Exelon Generation.

Peach Bottom Atomic Power Station, Units 2 and 3
Renewed Facility Operating License Nos. DPR-44 and DPR-56
NRC Docket Nos. 50-277 and 50-278

Subject: Response to Request for Additional Information - License Amendment
Request for Use of Neutron Absorbing Inserts in Units 2 and 3 Spent Fuel
Pool Storage Racks

Response to Request for Additional Information

Figure 1 – Comparison of RACKLIFE predicted areal density vs. BADGER measurements

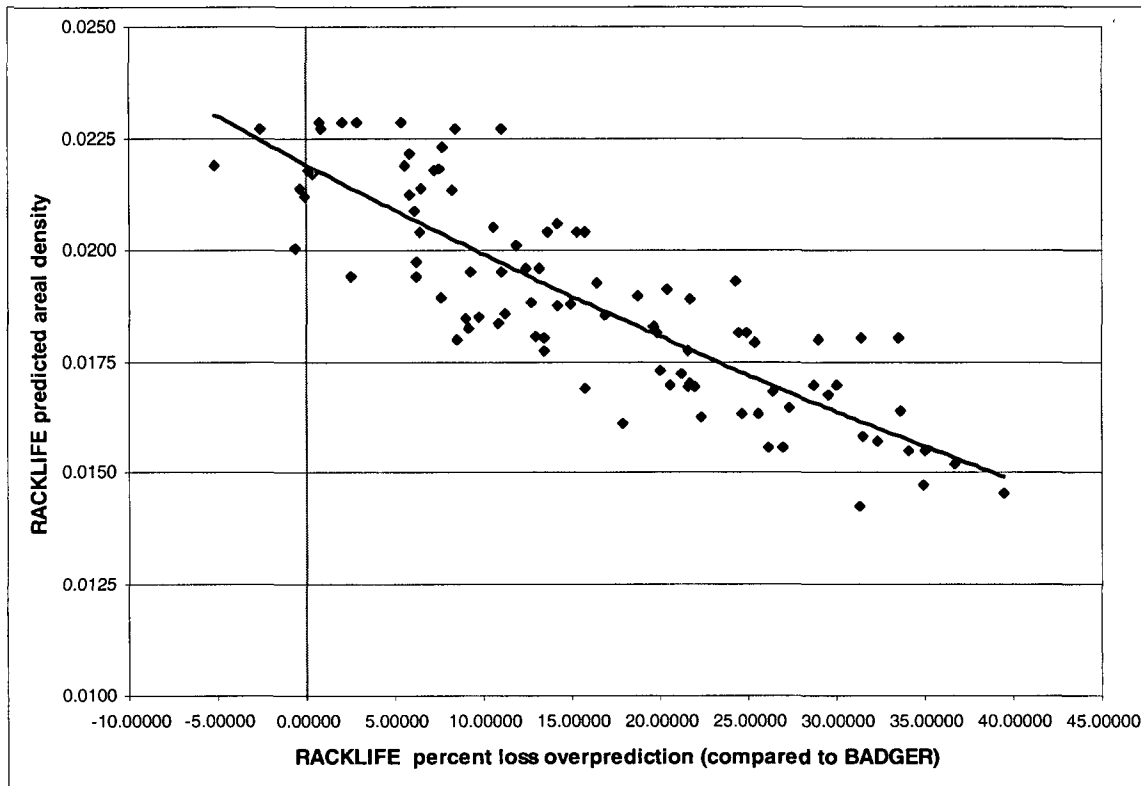
RAI-38: Discuss how the BADGER data is used to verify RACKLIFE. In addition, discuss how the BADGER measurement sample size is chosen and whether the sample size provides a statistically representative sample of the entire population of panels which bounds the worst-case degradation.

As part of the development of the RACKLIFE model, the escape coefficient is chosen to ensure the RACKLIFE prediction exceeds the actual BADGER data by at least 16% on average (two standard deviations for the BADGER measurement uncertainty). For PBAPS, this resulted in all RACKLIFE predictions for highly degraded panels exceeding the level of degradation measured by BADGER for the most recent BADGER testing. See Attachment 2, Figure 1 for more detail.

panels is shown in Figure 1. This figure also clearly shows that the 5 BADGER percent loss measurements that exceed the RACKLIFE predictions are all at high areal densities with only limited Boraflex degradation. The figure also shows that the RACKLIFE over prediction of percent loss increases as the degradation increases (as areal density decreases). This further supports the conclusion that the PB RACKLIFE models conservatively predict Boraflex degradation.

RAI-32 – PBAPS Calibration Cell

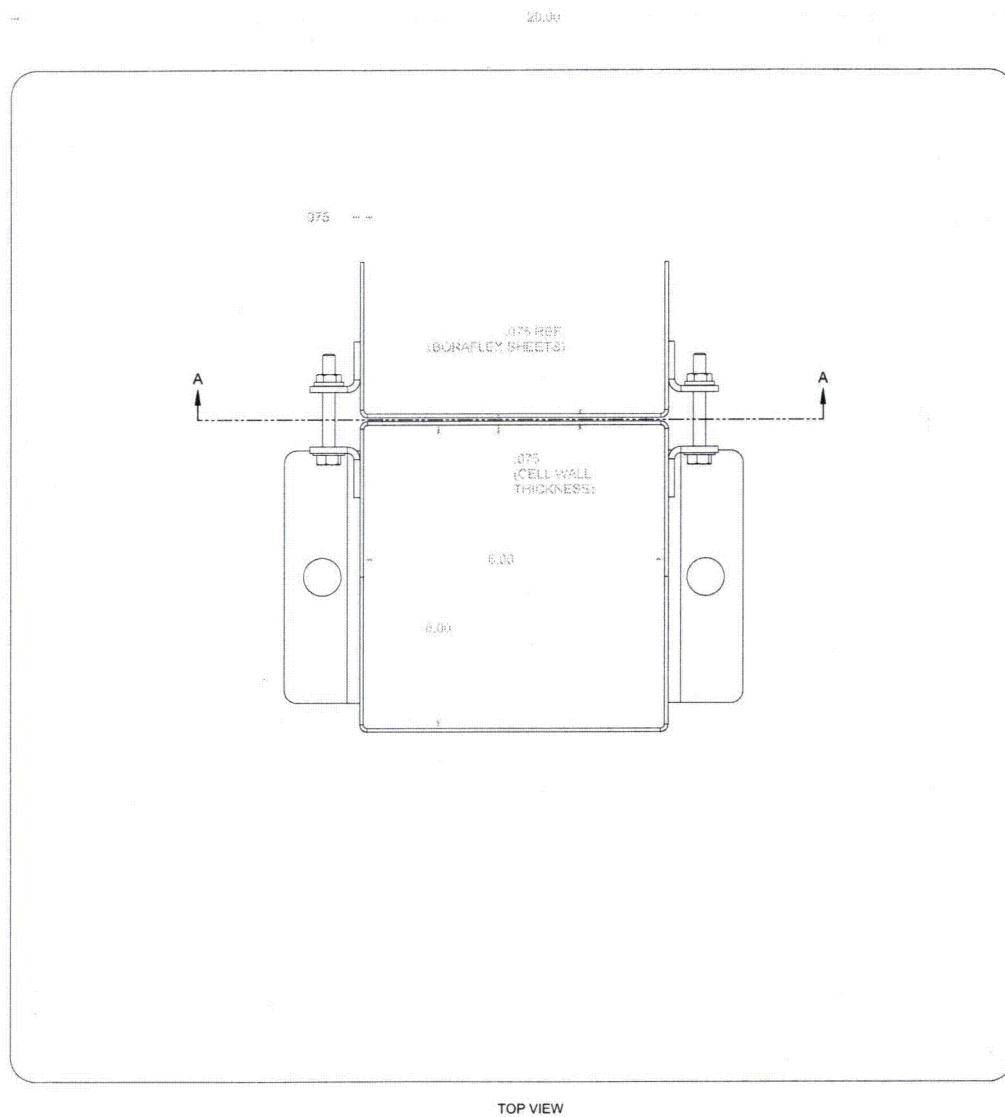
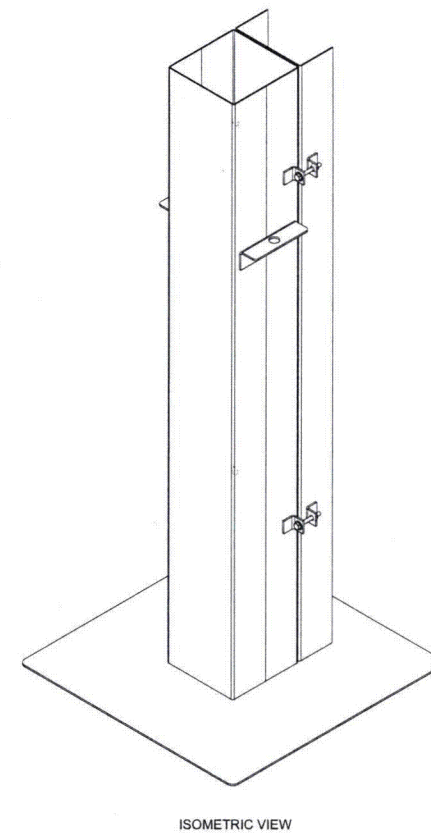
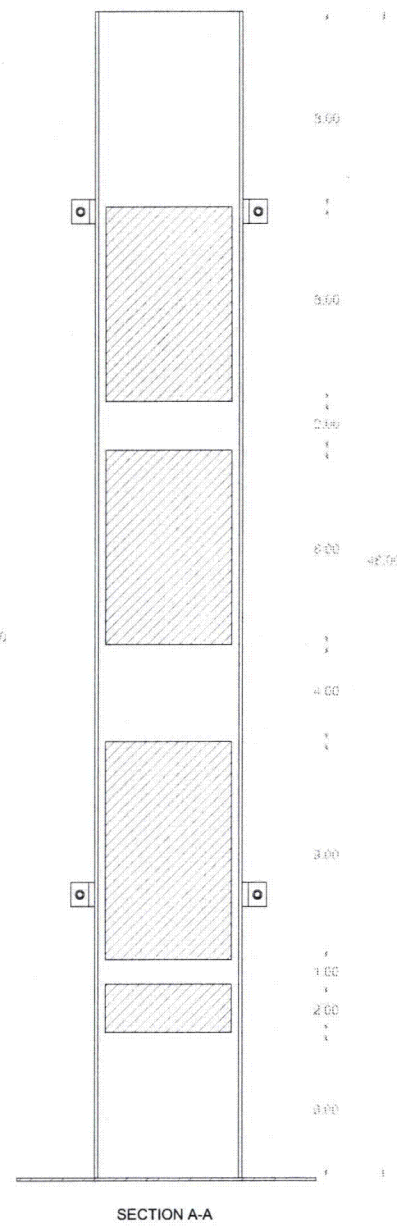
RAI-32: Provide a description, including a drawing, of the calibration cell used at PBAPS. Discuss the applicability of the calibration cell to the PBAPS BADGER campaigns from geometry and material composition considerations. Identify and evaluate their effects on uncertainties in determining the areal densities and the gap sizes.

The calibration cell (see Attachment 5, "RAI-32 - PBAPS Calibration Cell") at PBAPS is comprised of three Boraflex standards sandwiched between two square stainless steel storage cells. The calibration cells are affixed to a 24-inch square stainless steel base plate. Each calibration cell is formed by seam welding two stainless steel U-channels together along their edges to form a square storage cell. Each calibration cell has a 6-inch inner dimension and the walls are 0.075 inches thick. The calibration cell used at PBAPS was developed for EPRI in 1995 and was developed initially to be used at all BWR plants in the U.S. The source and detector heads when in the calibration cell are separated by two stainless steel walls that are 0.075 inches thick, whereas the PBAPS cells have one 0.075 inch wall and one 0.020 inch thick wrapper plate. However, given the difference in absorption and scattering cross sections for stainless steel and Boraflex, the configurations are neutronically similar. No uncertainty calculation has been performed for the calibration cell at PBAPS. At Peach Bottom the actual zero-dose panels are used as the reference panels for calibration, and any impact on the uncertainties from these panels is included in the overall BADGER uncertainties as described in RAI-35.
